DATE: September 15, 2023
TO: All Bidders
FROM: Renée Knight, Purchasing Specialist
SUBJECT: Addendum 1 – Bid #658, Oxnard College Campuswide HVAC Project

Bid#658: Oxnard College Campuswide HVAC Project
Addendum #1

DRAWING
NUMBER : M4.0

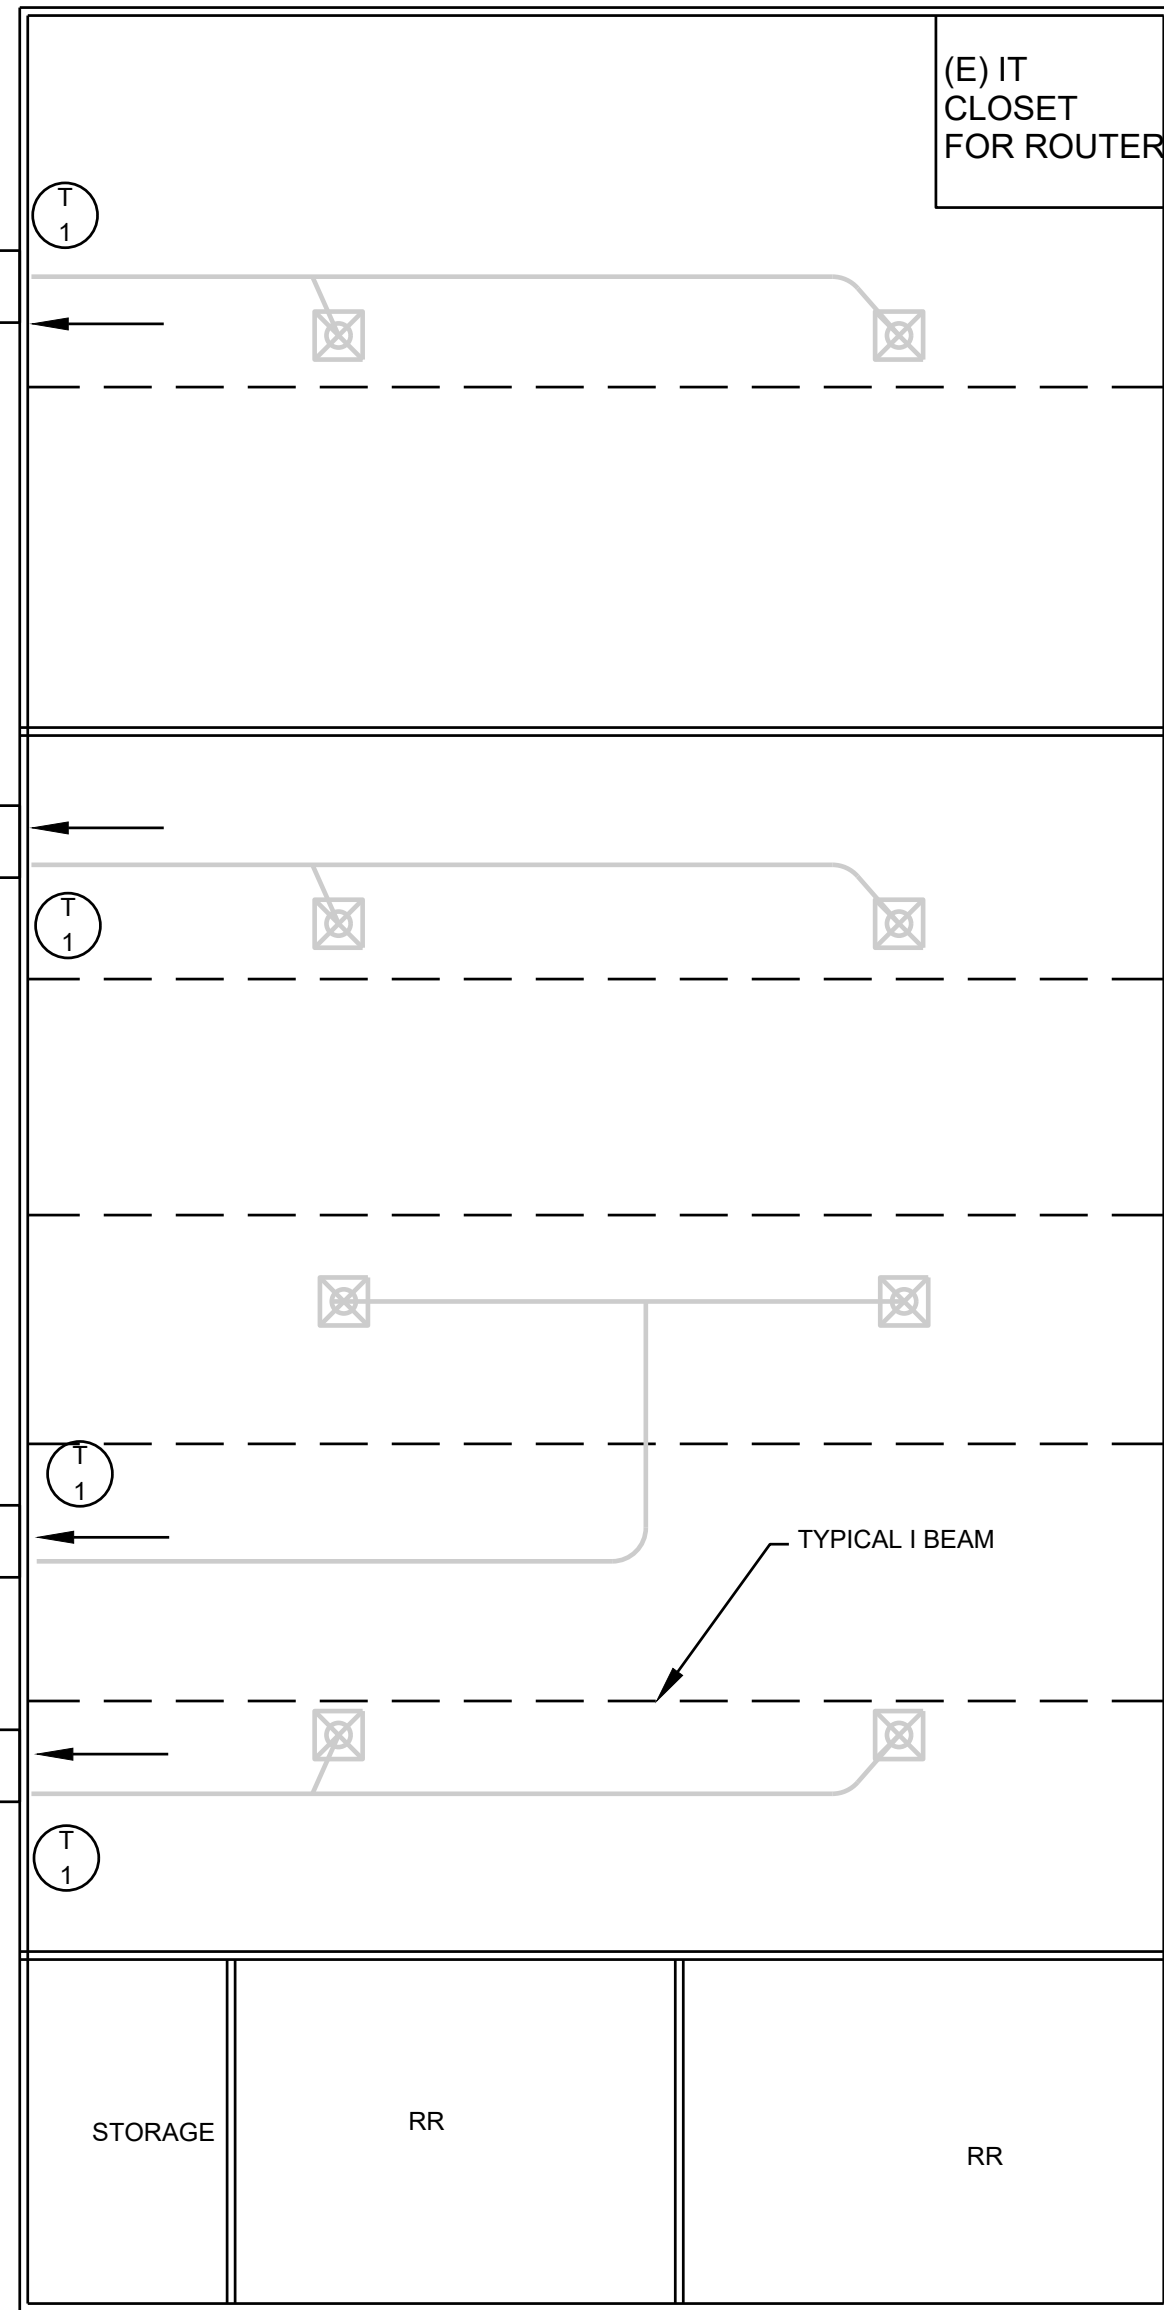
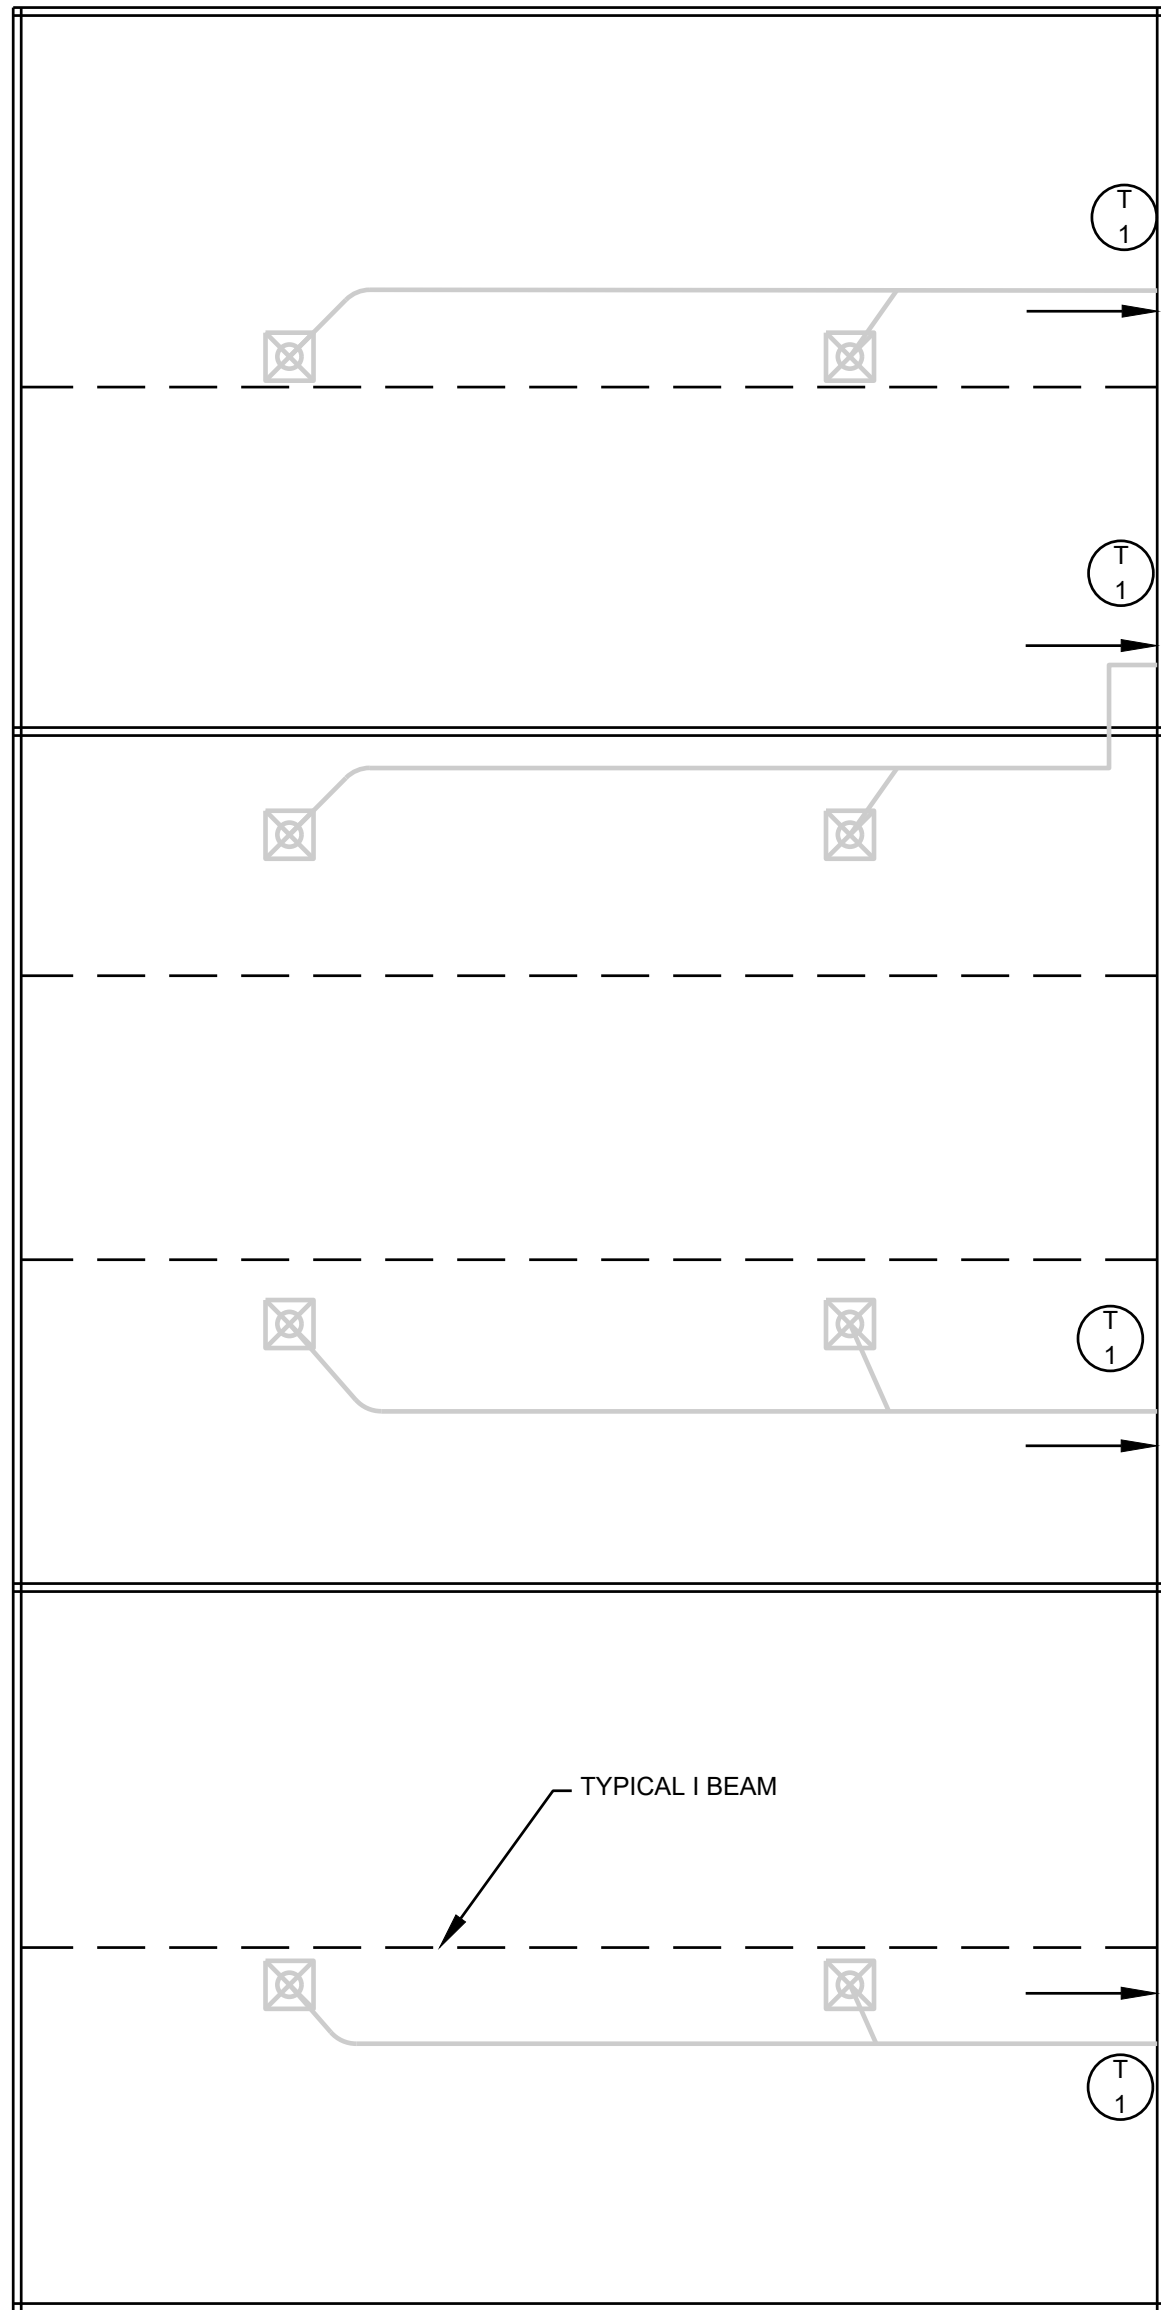
7. Reference Sheet M4.0 – Include UV Lights as a factory option. Typical 16 units.
8. Reference Sheet M5.0 & M6.0– All refrigerant pipe shall be rigid type ACR with brazed fittings. Pipe shall be installed straight, true, level and parallel to building elements. Interior insulation shall have miter glued joints at elbows and tees neatly installed. Exterior jacketing shall be installed in a neat professional manner with proper laps and sealed. Piping shall be properly supported with insulation inserts and shields.
